STATE OF WASHINGTON
DEPARTMENT OF ECOLOGY

August 6, 2018

**Re: The Boeing Everett Site
Final Decision to Submit a Supplemental Feasibility Study
Agreed Order DE96HS-N274**

FIGURE 2a

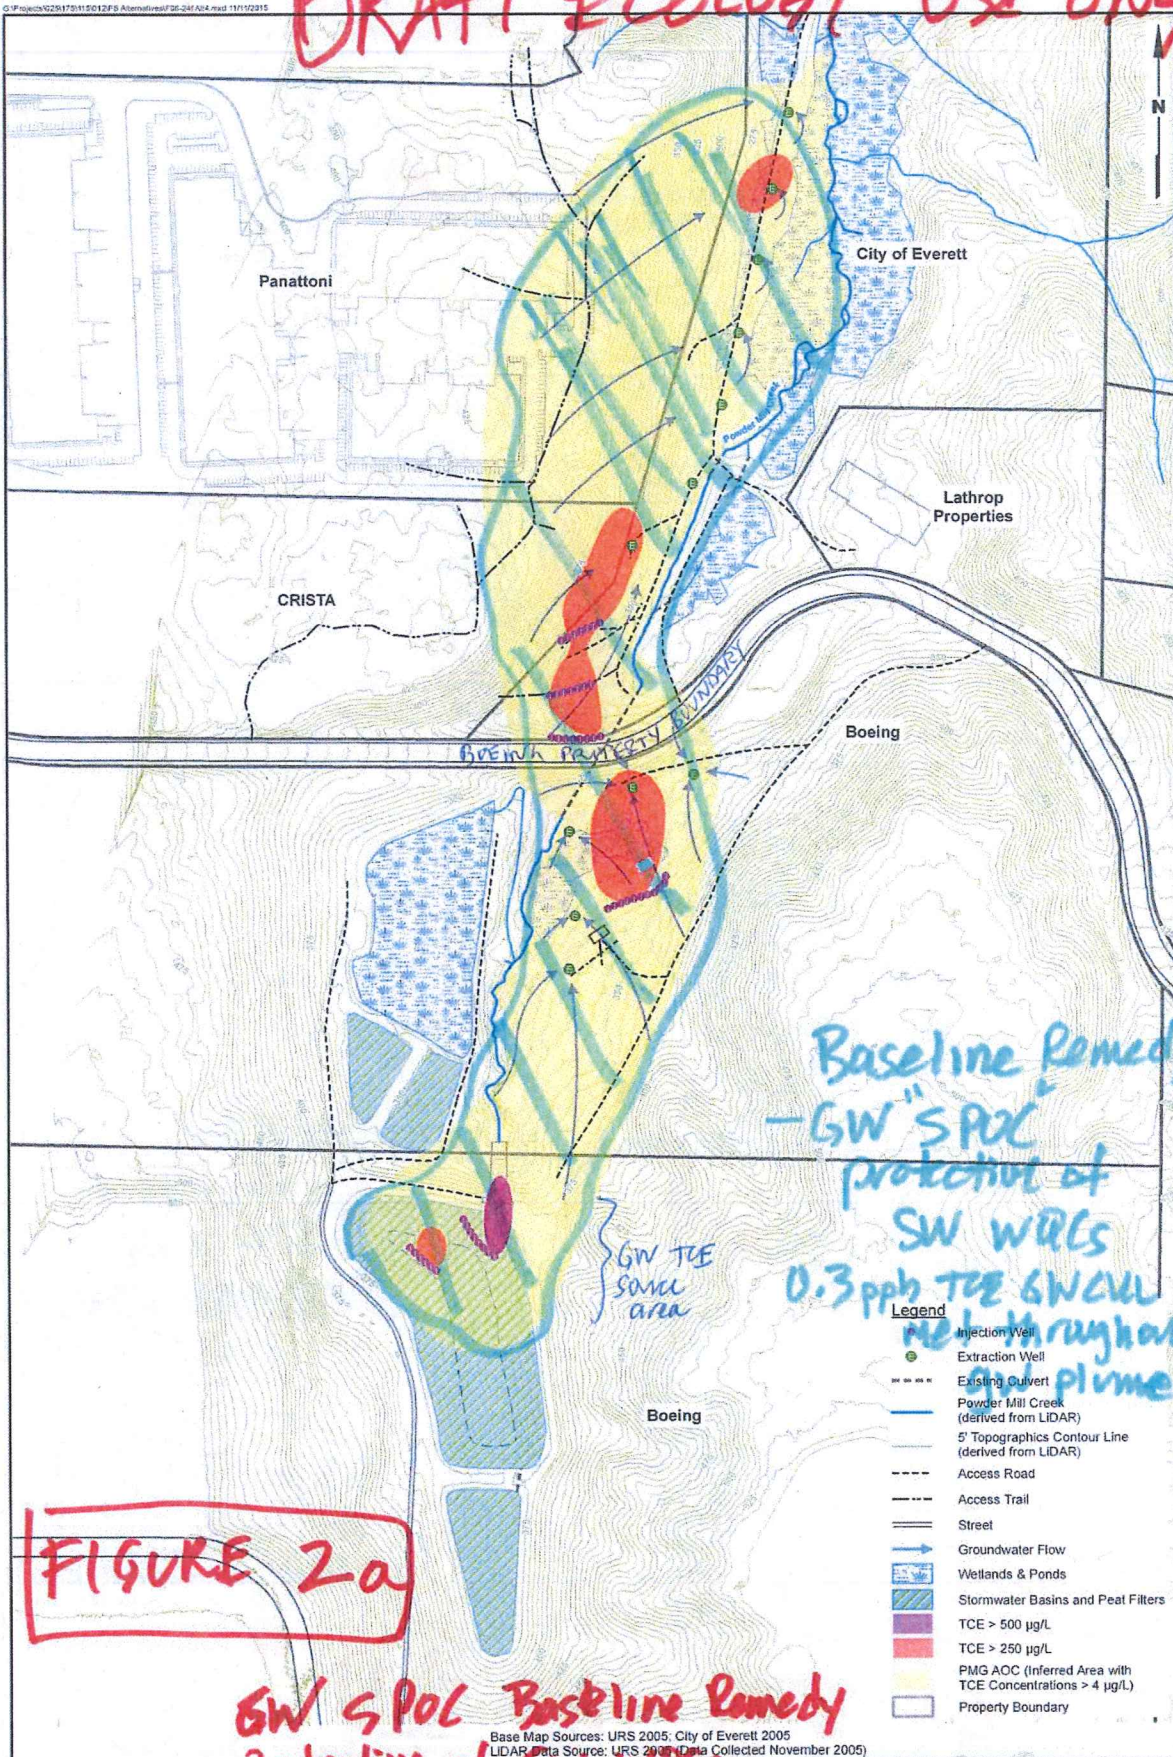
- i. Groundwater “Standard Point of Compliance” throughout the TCE groundwater source area and throughout the downgradient plume (see Attachment B, Figure 2a);
- ii. Groundwater conditional point of compliance immediately downgradient of the TCE groundwater source area – on Boeing property (see Attachment B, Figure 2b);
- iii. Groundwater conditional point of compliance at the Boeing property boundary and within groundwater⁵ immediately upgradient of the creek on Boeing property (see Attachment B, Figure 2c); and
- iv. Groundwater conditional point of compliance immediately upgradient⁶ of the creek on Boeing property and City of Everett property (see Attachment B, Figure 2d).

1. Using WAC 173-340-360, evaluate the new remedial alternative for groundwater contamination using EISB in the TCE groundwater source area and Ecology modified-DGR for all downgradient TCE groundwater contamination (on Boeing property and on City of Everett property) using the four groundwater points of compliance.
